SERVICE PROCEDURE

14502

SUBJECT: SAFETY RECALL

STEERING GEAR MOUNTING BOLTS on certain DuraStar® Models built 11 January 2014 through 23 January 2014 with feature codes 05PRG, 05PRR, 05PRU, 05PRV or 05PSM.

Figure 1. Steering Gear Bolt Mounting Locations.

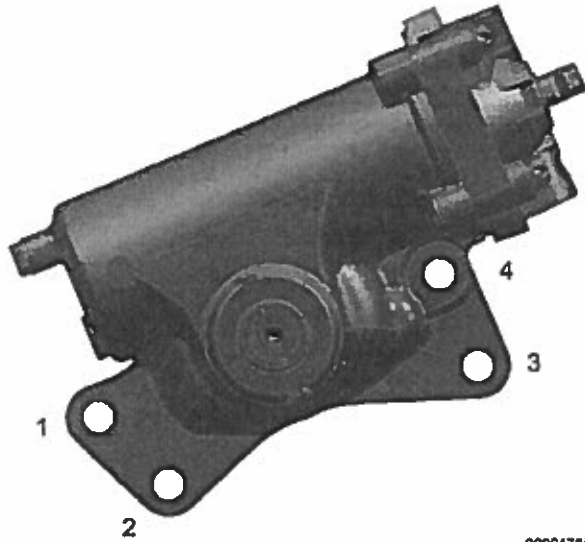
The mounting bolts that fasten the steering gear to the vehicle frame may not be the correct bolt specified. These bolts could yield, resulting in either looseness of steering or the potential for loss of steering if all four mounting bolts were to yield. An unexpected loss of steering may result in a vehicle crash, which may result in property damage, personal injury, or death.

7. Using steering gear reference (Figure 1, Items 1 - 4 and Table 6) and an abrasive material, remove paint from thread end of bolt and inspect color:
 - If bolt(s) appears black after paint removal, no replacement is necessary. Repaint inspected bolt.

17. Lift engine enough to clear front engine mounts.
 18. Slide crossmember assembly forward.
 19. Remove suspect bolt(s) one at a time.
 20. Install replacement steering gear bolt(s) and nut(s). Using a torque wrench, torque bolts to 240 lb-ft (320 N·m).

33. Unlatch and open hood.
34. Access steering gear mounting location.
35. Using steering gear reference (Figure 1, Items 1 - 4 and Table 6) and an abrasive material, remove paint from bolt and inspect color:
 - If bolt(s) appears black after paint removal, no replacement is necessary. Repaint inspected bolt.
 - If bolt(s) appears gray, proceed to next step.
36. Remove the suspect bolt(s) one at a time.
37. Install replacement steering gear bolts. Using a torque wrench, torque bolts to 240 lb-ft (320 N·m).
38. Paint replacement steering gear mounting bolts.
39. Close and latch hood.
40. Remove wheel chocks.
